Access Compliance Report

Public Rights-of-Way

Intersection ID: 14145	Main Street: MT_VERNON_AV	Cross Street: DILWORTH_CRESCENT_RW	Location: NW
ADA ID: 36E8D4FD5014	Ramp Type: PerpDiag	Initial Pass/Fail: Fail	Overall Compliance: No
		Severity Score: 12.5

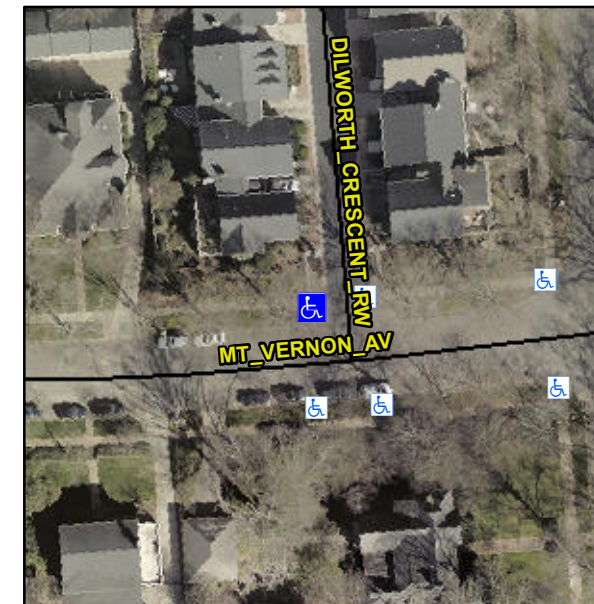
Compliance	Description	Data	Compliance	Description	Data
N/A	Ramp Length (in)	48.0	Yes	Ramp Slope (%)	5.8
Yes	Ramp Width (in)	48.0	No	Ramp XSlope (%)	5.2
N/A	Flare Type LT	N/A	N/A	Flare Type RT	N/A
N/A	Flare Slope LT (%)	N/A	N/A	Flare Slope RT (%)	N/A
N/A	Flare Traversable LT?	N/A	N/A	Flare Traversable RT?	N/A
N/A	Landing Length (in)	N/A	N/A	DWS Provided?	N/A
N/A	Landing Width (in)	N/A	N/A	DWS Contrast?	N/A
N/A	Landing Slope (%)	N/A	N/A	DWS Length (in)	N/A
N/A	Landing X Slope (%)	N/A	N/A	DWS Full Width?	N/A
N/A	Landing Curb? (Y/N)	N/A	N/A	DWS Offset (in)	N/A
N/A	Shared Landing?	N/A			
N/A	Gutter Ponding?	N/A	N/A	Gutter Slope (%)	N/A
N/A	Gutter Lip Ht (in)	1.0	N/A	Gutter X Slope (%)	N/A
N/A	Painted X Walk1?	No	N/A	Painted X Walk2?	No
	X Walk 1 Direction	To S		X Walk 2 Direction	To E
N/A	X Walk 1 Width (in)	N/A	N/A	X Walk 2 Width (in)	N/A
	X Walk 1 Slope (%)	3.5		X Walk 2 Slope (%)	1.2
	X Walk 1 X Slope (%)	0.6		X Walk 2 X Slope (%)	1.6

Remove & Replace Curb Ramp With Two New Directional Ramps or Equivalent.
